9752 GE 3S2P Battery Pack Main Board

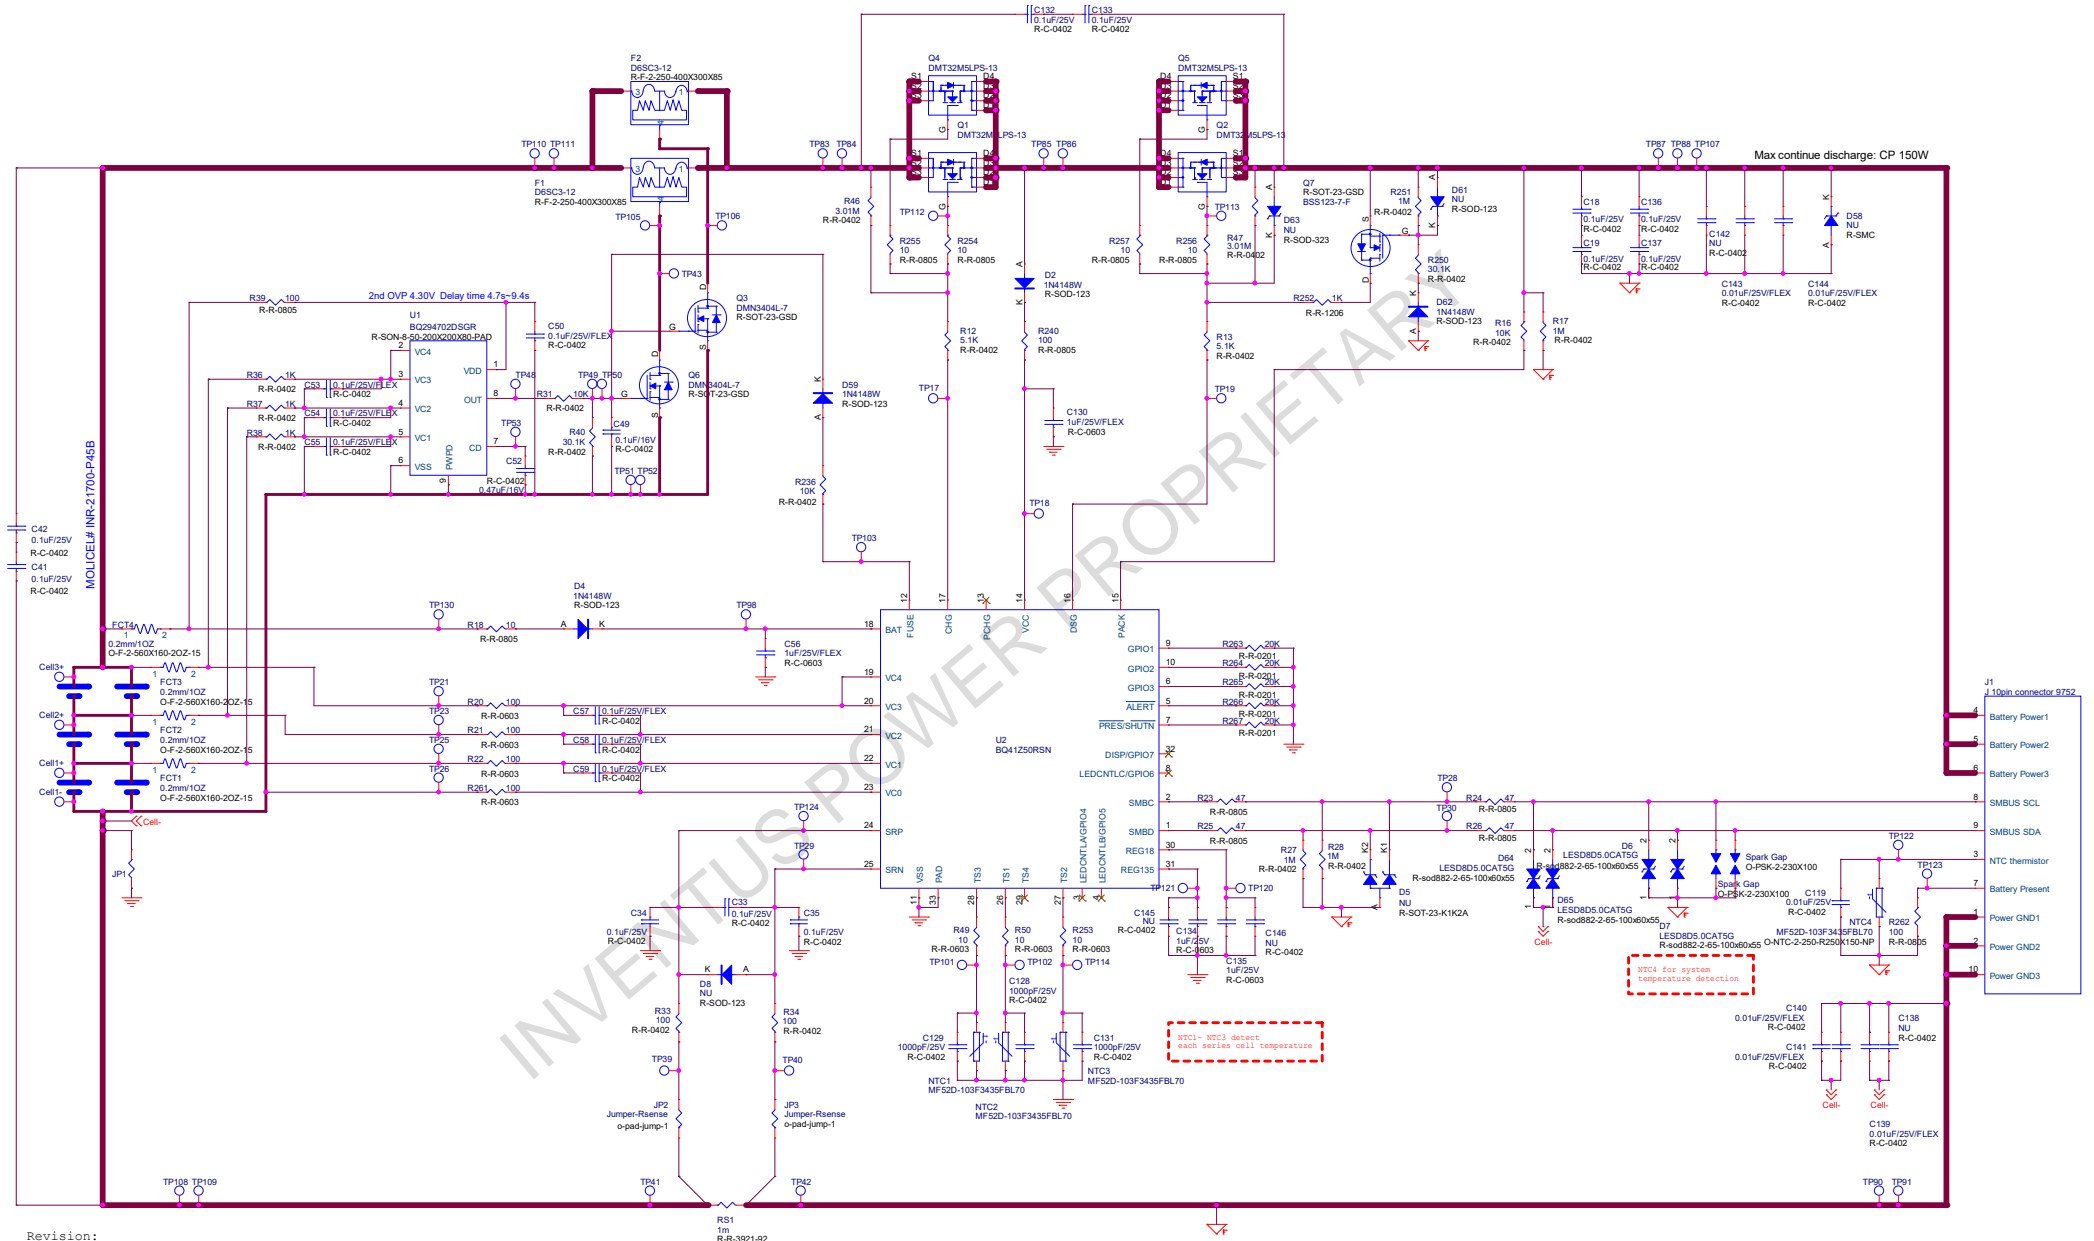
Revision:
X1: New release.
X2: Change R262 to 100 OHM; Change NTC1-NTC4 to MF52D-103F3435FBL70; Change Q1,Q2,Q4,Q5 to DMT32M5LPS-13
X3: Change NTC1-NTC4 to MF52D-103F3435FBL70
X4: Add C138,C139,C140,C141,D64,D65; Change RS1 to 3921 footprint
X5: Add C142,C143,C144,C145,C146; Remove TP128; Change R23,R25 to 0805 footprint
Change D6,D7,D64,D65 to LESD8D5.0CAT5G; Change D5 to NU
